### REMARKS

#### Drawing Objections

VERSION MARKED TO SHOW CHANGES

Fig. 1

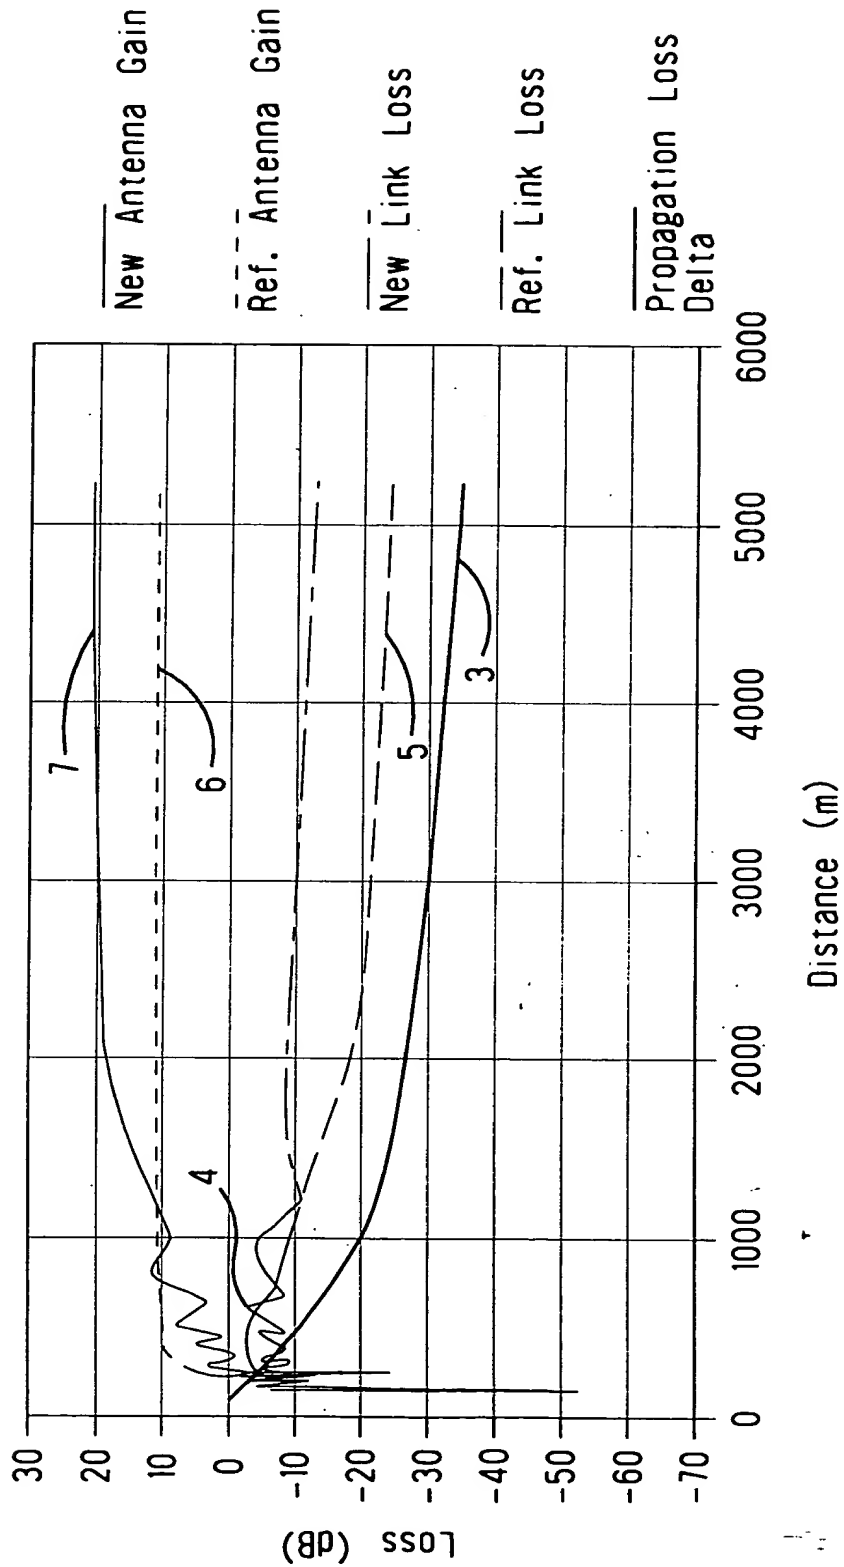
Figure 1 was objected to as having an improper left margin. Applicant assumes that the Office Draftsman meant the top margin, as Figure 1 is oriented in landscape and the left margin, when viewed in landscape, appears to be appropriate.

A new Figure 1 is enclosed which is believed to have the correct margins. Withdrawal of the objection is respectfully solicited.
